**SUBJECT: NEW VEHICLE DEMONSTRATION / DELIVERY HOLD -  
Compliance Recall 18C06**  
Certain 2018 Model Year Edge and MKX Vehicles  
Incorrect Door Striker Bolts

## CERTAIN 2018 MODEL YEAR EDGE AND MKX VEHICLES — INCORRECT DOOR STRIKER BOLTS

FIGURE 1

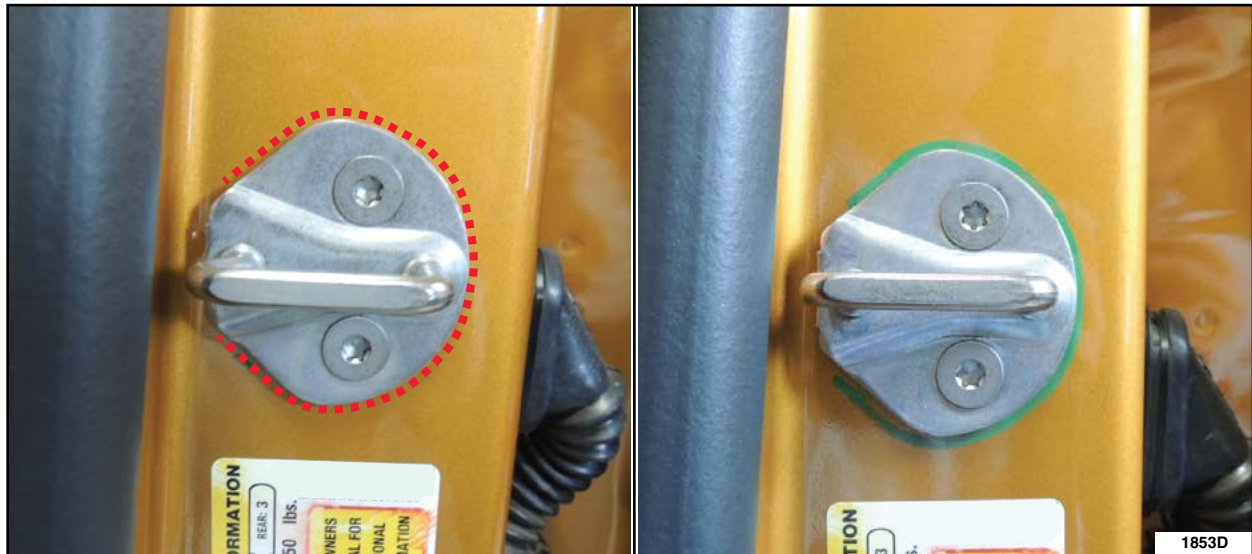
1. Trace the location of the striker assembly with a non-permanent/erasable pen such as a grease pen or paint stick. See Figure 1.
